**Technical Service BULLETIN**

Title: **M.I.L. "ON" DTC P0420**  
Models: **'03 – '04 Matrix (1ZZ-FE)**

REVISÉD  
**ENGINE**  
**EG026-04**

**TSB REVISION NOTICE:**

Figure 2. Location of Authorized Modifications Label on 2003 – 2004 Matrix

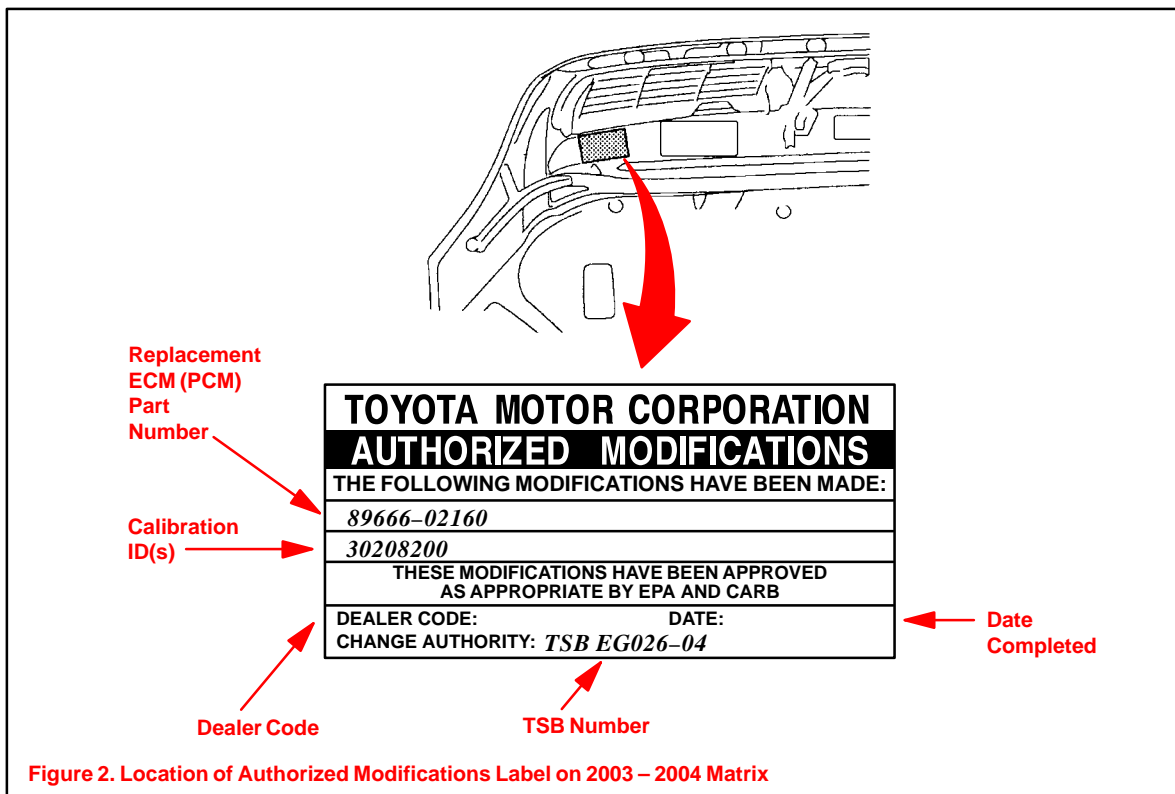
**October 8, 2004: Part number for replacement ECM (PCM) in Figure 2 on page 5 has been updated; Reference to section in Technical Information System (TIS) has been updated in "ECM (PCM) Replacement Procedure" on page 5. The previous TSB should be discarded.**

7. Enter the following information on the Authorized Modification Label shown below in Figure 2 using a permanent marker.
  - ECM (PCM) part number.
  - New ECM (PCM) calibration number.
  - Your dealer code.
  - Reprogramming date.
  - This TSB number.
